300 SPEAR STREET

COMMENTS AND RESPONSES

SAN FRANCISCO PLANNING DEPARTMENT
2000.1090E

FIGURE 21a (NEW): REVISED PROJECT MAIN-STREET LEVEL

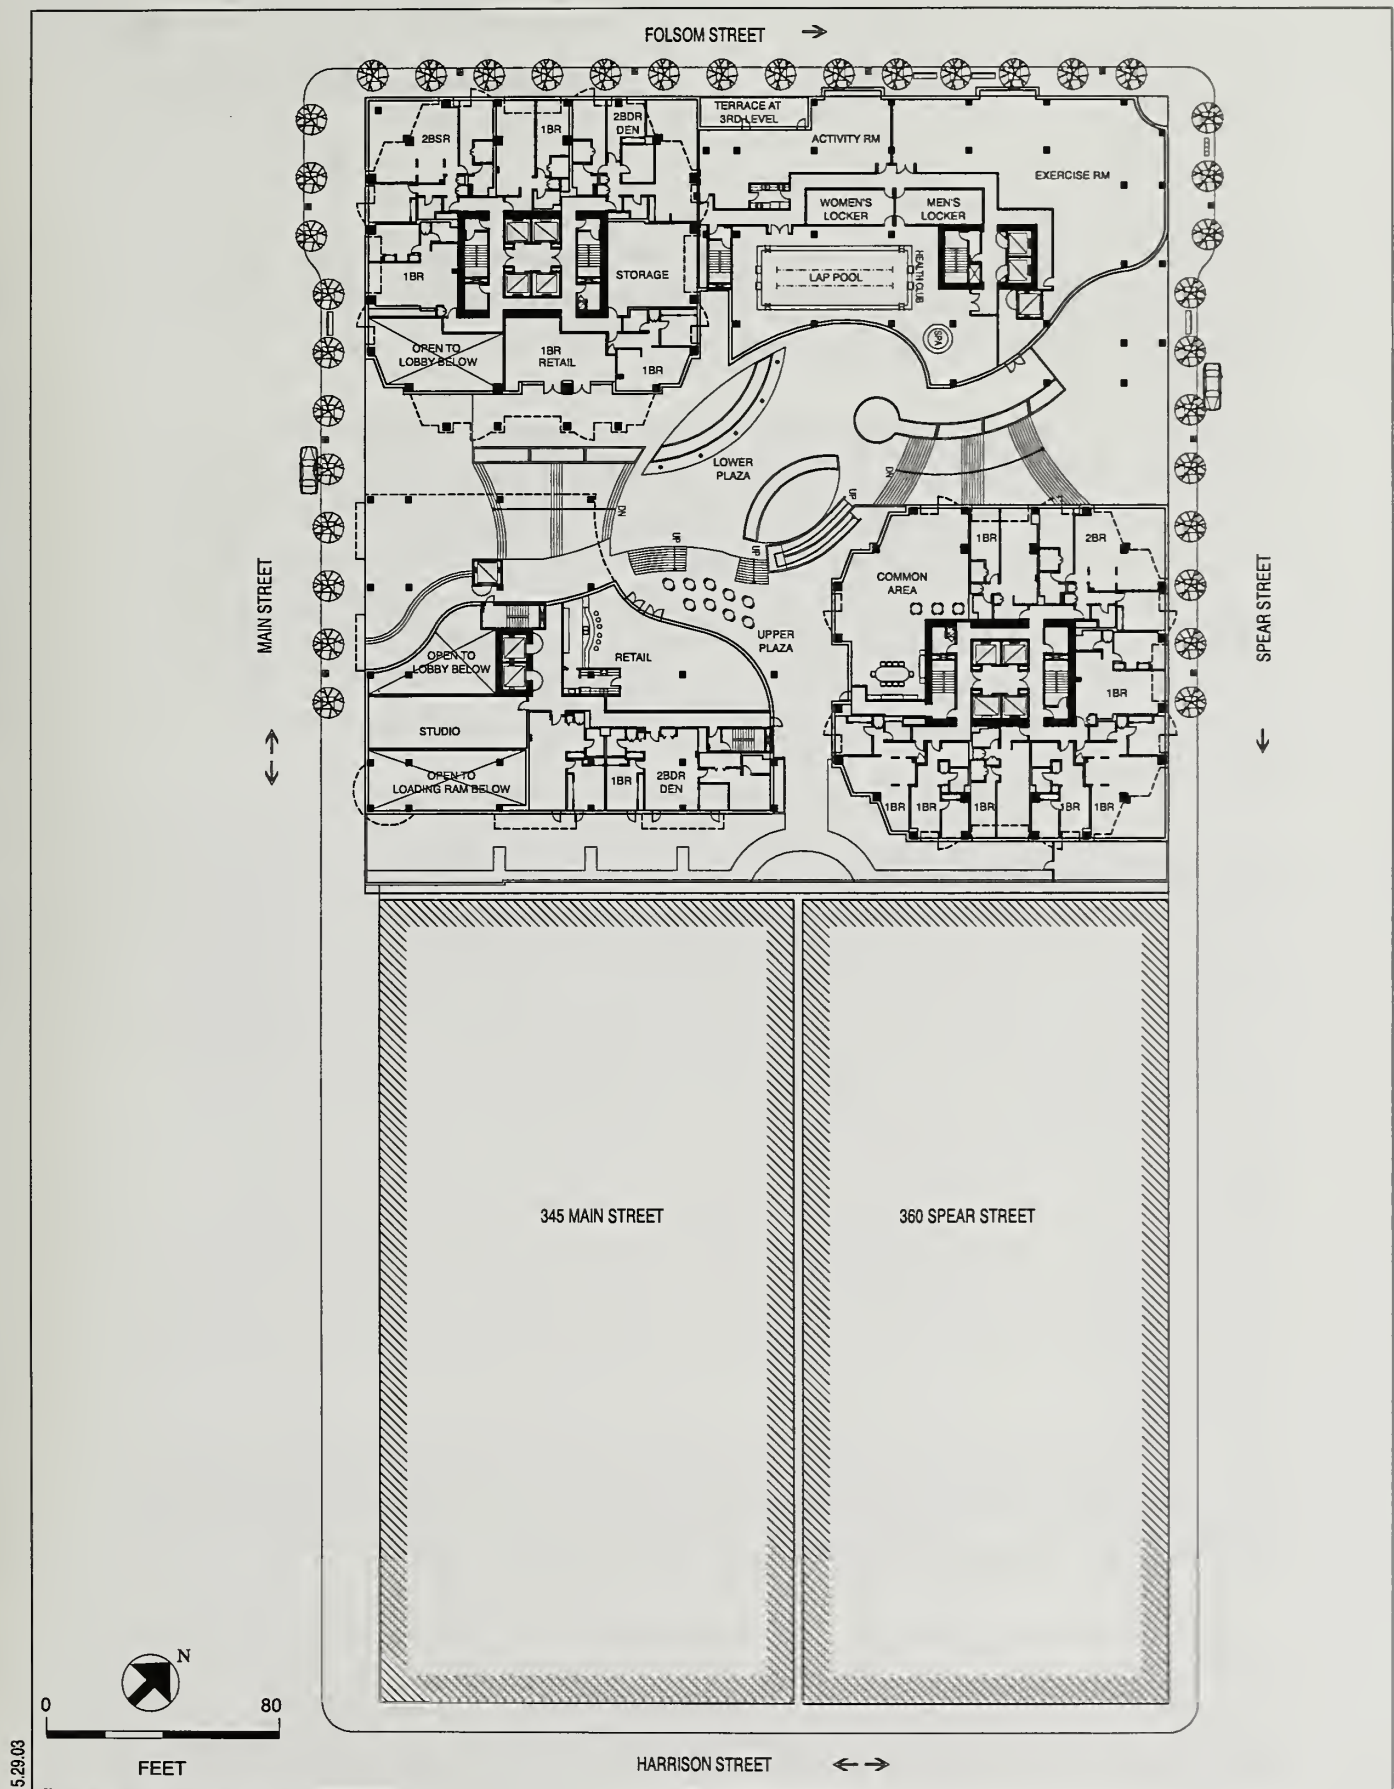
The proposed revisions would reduce retail gross square footage by 24,000 gsf and eliminate all of the office space. The revised development project would include 90 fewer parking spaces. The parking layout has been redesigned, so there would be six subsurface levels instead of five. It would increase common and private open space by 15,575 gsf and 850 gsf, respectively; it would reduce publicly accessible open space by 2,600 sq. ft. It would include up to the same number of residential units as were analyzed in the Draft EIR (820 units). The design of the development project would be similar to the Draft EIR proposal, with two residential towers rising above two 80-foot-tall building bases or podiums (the Main Street and Folsom Street podiums) to total heights of about 350 and 400 feet above the ground level, respectively. The podiums would enclose an interior landscaped courtyard. Rather than porte cocheres on Spear and Main Streets, the revised development proposes vehicle pull-outs on Main and Spear Streets adjacent to the open areas leading to residential lobbies. (See Figure 21a: Revised Project Main Street Level, and Figure 21b: Revised Project Courtyard Level.)

The revised development project would be a high-rise residential building with 720 to 820 residential units in 915,000 gsf of space and 36,000 gsf of retail space. It would provide about 890 parking spaces (820 spaces for residential and 70 spaces for commercial uses) in six levels of subsurface parking. The revised project would provide about 49,375 gsf of common open space on podium rooftops and in the form of an interior courtyard; up to 8,355 gsf of private open space; and about 700 gsf of publicly accessible open space to meet requirements for the retail use.

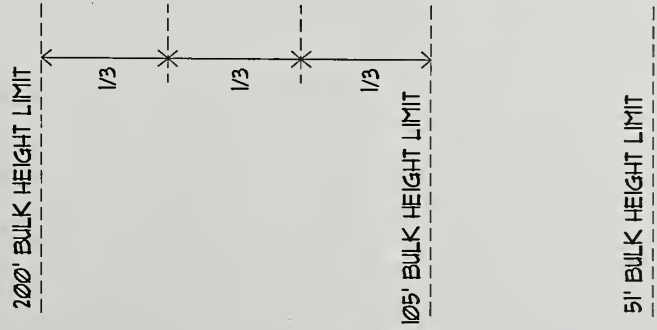
Impacts: We would request that the three alternatives B, C & D have the inclusion of massing models and/or photo simulations so as to assess the impact of the designs of each on public views. We also request that the EIR should include massing models and/or photo simulations for the currently allowable height limits and density requirements for the site. Comparison of these with the massing model/photo simulations of the B, C & D Alternatives will provide for a more complete assessment of the impacts on public views for each and provide for a more thoughtful analysis of the alternatives to the proposed projects. (*Andrew Phipps Brooks, General Manager, BayCrest Towers, on behalf of the BayCrest Towers Residential Association*)

In response to the commentor's request for additional figures to assess the visual impact of the alternatives, an additional section for Alternative B is provided. This figure is added to the EIR as Figure 36a: Alternative B Section, and is shown on p. C&R-39. Photo simulations of Alternatives B, C and D are also provided on the following pages to assist the reader (see Figure

C&R-A: Alternative B Views; Figure C&R-B: Alternative C Views; and Figure C&R-C: Alternative D Views). The visual impacts of Alternatives B, C, and D are discussed on pp. 186, 188, and 194 of the EIR, respectively. The commentor further requests massing models and/or photo simulations to illustrate the currently allowable height and bulk limits for the site. Since Alternatives B and C reflect development conforming to existing height and bulk restrictions, this request is met in Figures C&R-A and C&R-B.
